Capital Project No. WP-169
Long Term Control Plan II

**Combined Sewer Overflow
Long Term Control Plan
for
Jamaica Bay and Tributaries**

**Appendix G: Supplemental Documentation
August 14, 2019**

Responses to DEC Comment Letter Dated December 21, 2018

Figure ES-8. GI CSO Baseline and GI Expansion in Recommend Plan

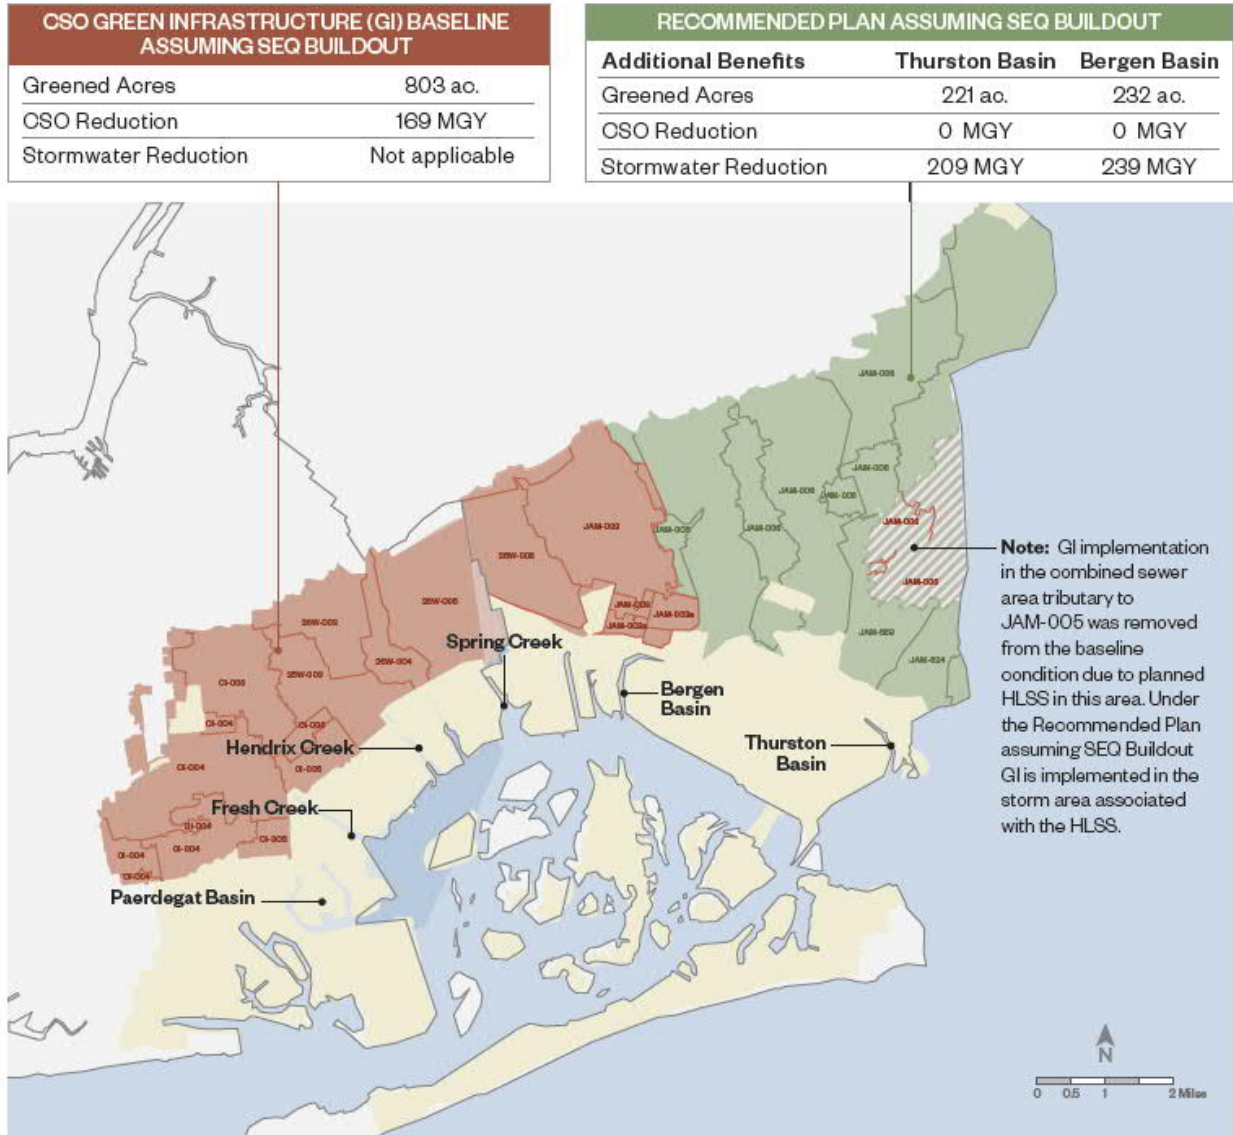
5. **DEC Comment: Chapter 8.** Provide figures (similar to Figure ES-8) that show attainment levels for the entire Jamaica Bay as well as tributaries for fecal coliform, enterococcus, and dissolved oxygen standards for the selected alternative. The figures provided, such as Figure ES-2, only show the tributaries and the northern half of the Bay. Additionally, provide a similar figure in the Executive Summary for the baseline, 100 percent CSO reduction, and selected alternative showing the attainment levels for the proposed enterococci 130 cfu/100mL STV standard.

As illustrated in Figure ES-8 (below), the majority of the Baseline GI is implemented within the portions of the collections system where the combined sewer drainage systems have been built-out, resulting in a ratio of CSO reduction per impervious area managed that is consistent with the City-Wide projections. However, the additional GI proposed under the LTCP Recommended Plan is located in the areas planned for the SEQ Sewer Buildout and therefore the calibrated landside model for this drainage area presented in the LTCP had unusually low runoff coefficients attributed to the lack of storm sewers in the area. As a result, the initial projected benefits of GI in reducing end-of-pipe wet weather volumes were much lower than typically anticipated. Regardless, GI provides ancillary benefits in capturing storm flow such as upland flood relief, reduction in carbon footprint, ecosystem habitat creation, heat island reduction and property value benefits.

The SEQ Buildout will implement HLSS in the combined Laurelton area tributary to Thurston Basin. Since HLSS is planned, GI implementation has been removed from the Baseline and Recommended Plan, both with and without the SEQ Buildout. This GI implementation effort includes 74 greened acres; in the prior Baseline condition it results in a reduction of 32 MGY of CSO to Thurston Basin. Under the Recommended Plan, both with and without the SEQ Buildout, this 74 greened acres of GI is now implemented in the storm area tributary to Thurston Basin. Figure ES-8 below provides the details of how the shift of the 74 green acres of GI to the storm area will impact the stormwater discharge to Thurston Basin under the Recommended Plan with SEQ Buildout scenario. Please see Section 5 for the details related to the impact under the Recommended Plan without SEQ Buildout scenario.

Figure 6-2. IW Subcatchments within Jamaica Bay Drainage Area

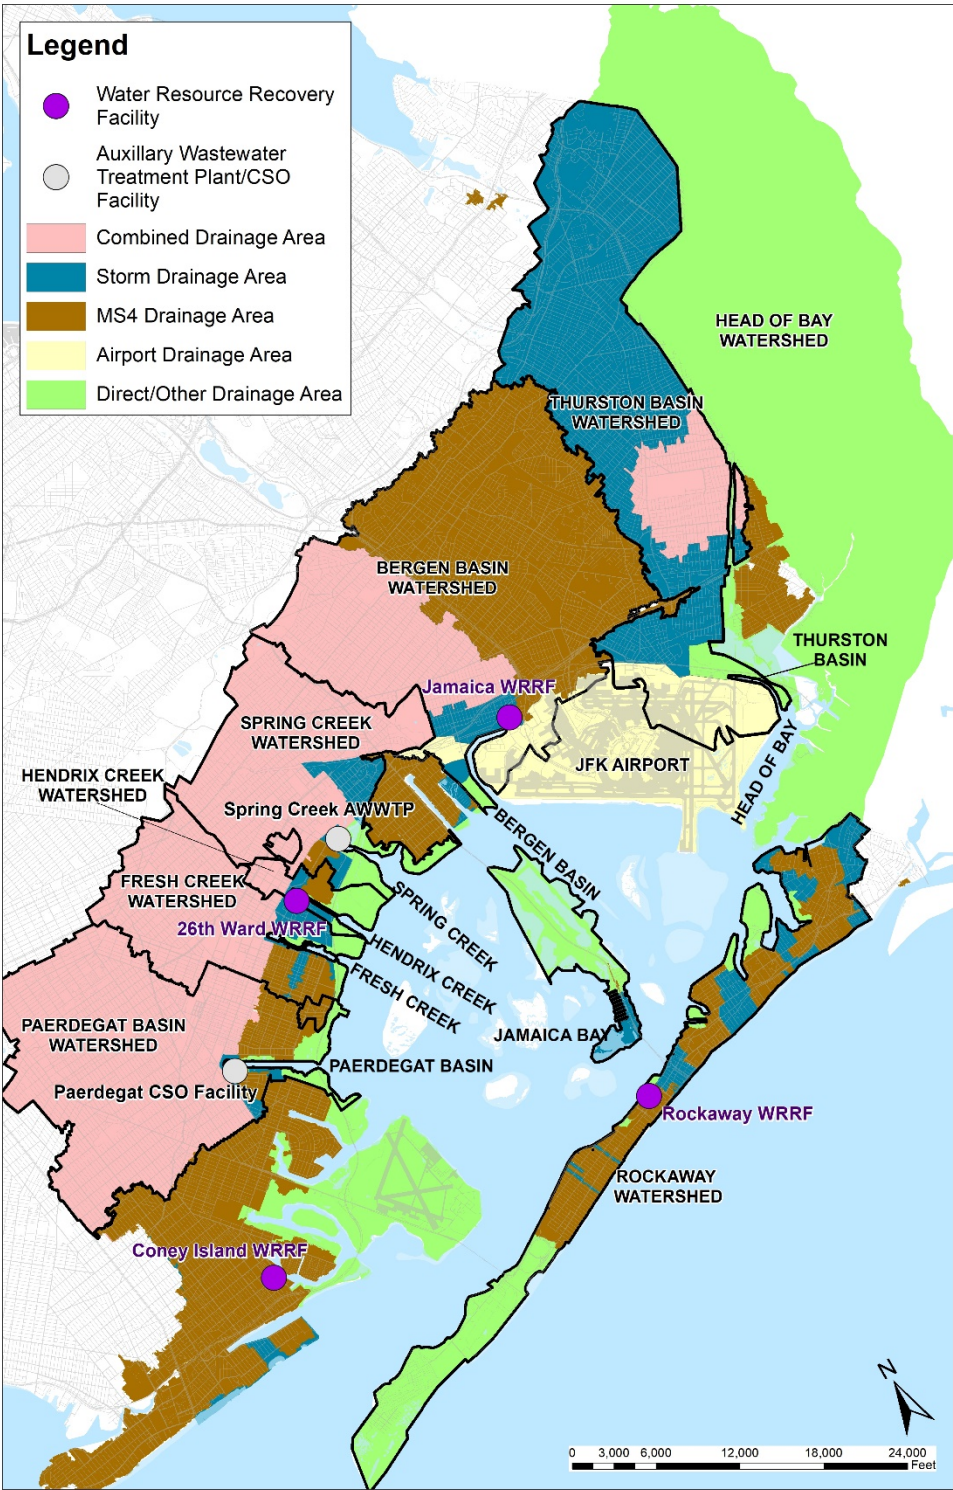
7. **DEC Comment:** Figures 2-3 and 6-2. Explain the difference between areas designated as “storm drainage” and “MS4 drainage”. In previous LTCPs, the City has not similarly differentiated the separately sewered areas in the drainage basins.
